Title:
ELECTRICAL SERVICES LAYOUT CONTAINMENT
TOWN HALL FIRST FLOOR
TENANT FIT-OUT ALLOCATION LAYOUTS

Project:
HORNSEY TOWN HALL

Dwg Number:
10687-E-02-TH-1101(3)

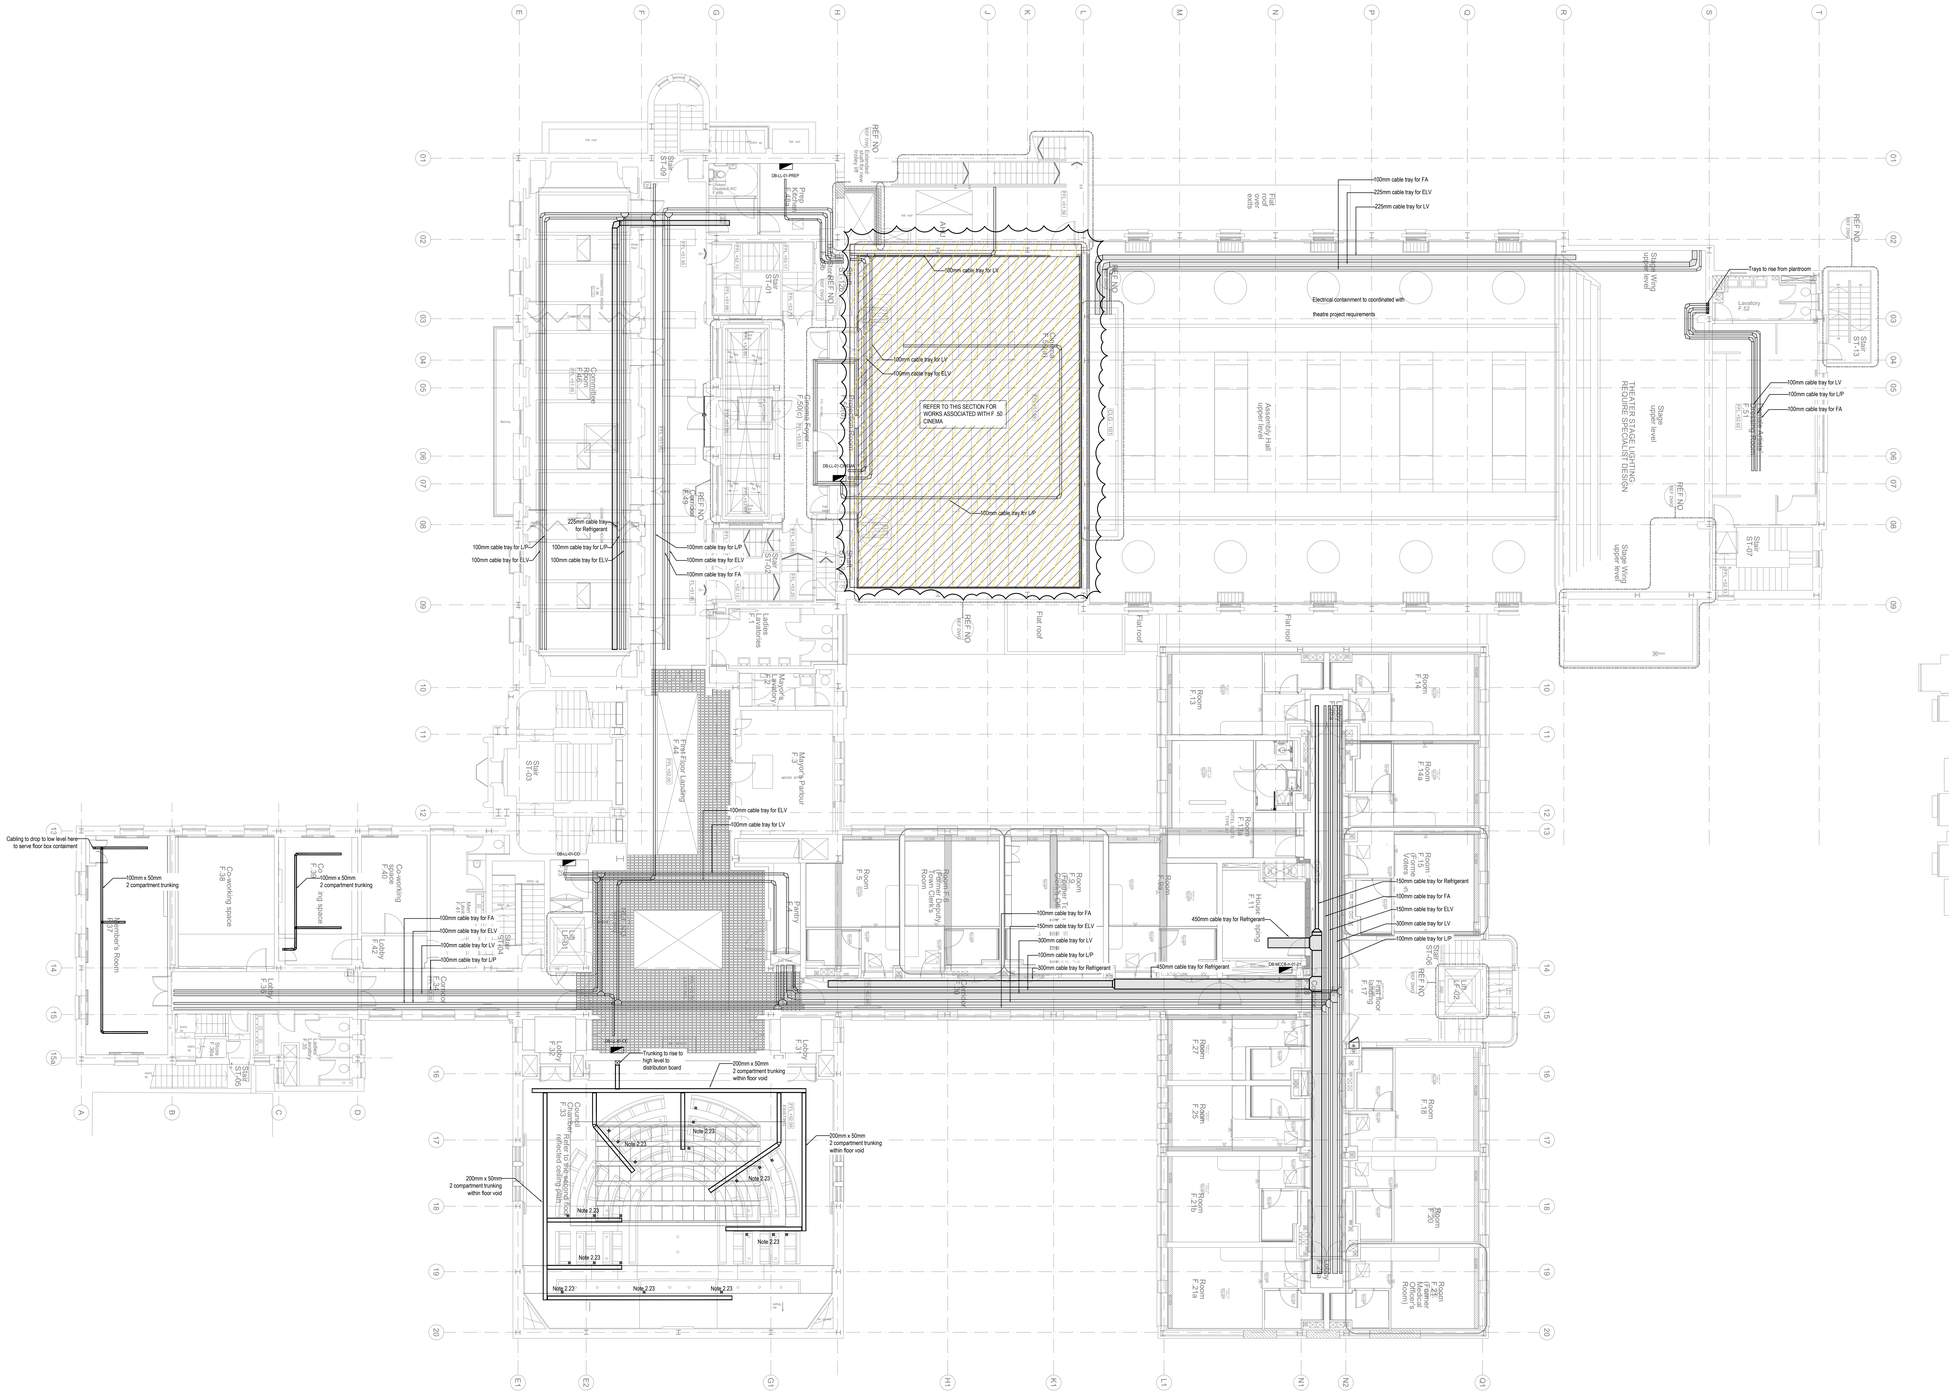
Responses to L&P Comments 27.01.2021
1. Please provide co-ordinated sections and details along corridor routes , within rooms. This to verify how access is maintained to all containment. See combined distribution details drawings.

2. Also to verify co-ordination with other services. Mains Power cabling cannot be inverted so cables fall to floor in an escape route under latest Building Regulations. See combined distribution details drawings.

3. Please depict invert levels for each section of containment. See combined distribution details drawings.
4. Containment needs to extend from circuit board and must not stop short with isolated sections shown. This has been updated.

5. Provide a series of drawings demonstrating containment sizing capacity and spare for each section. This does not fall under our scope, schedules are available to assertain amount of cables per tray and spare capacity can be determined from this.

6. Provide fire stopping details. By others.
7. Provide arrangement drawing for each distribution board. Comment not applicable to this drawing.
8. Provide fire stopping details at each bridging section. By others.

9. Provide support installation details. See combined distribution details drawings.
10. Demonstrate how containment concealed from view but fully accessible - All areas. By others
